ADDENDUM NO. 02

PROJECT: **VIGO COUNTY JUVENILE CENTER SALLYPORT**
202 Crawford Street, Terre Haute, Indiana 47807

DATE: **JULY 25, 2024**

FRAME ELEVATIONS

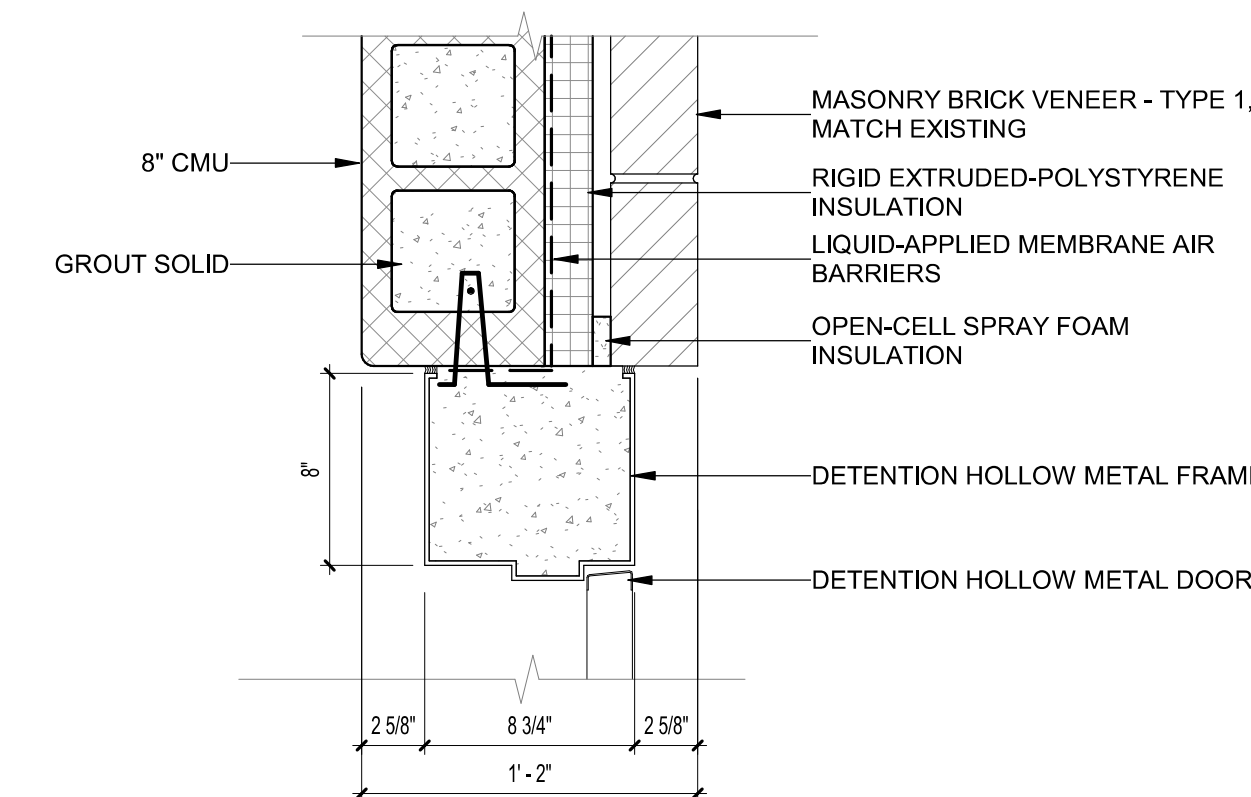
ITEM NO. 5. A3-1 DOOR AND FRAME SCHEDULE AND DETAILS

a. FRAME ELEVATION - Updated dimensions for frame F3.
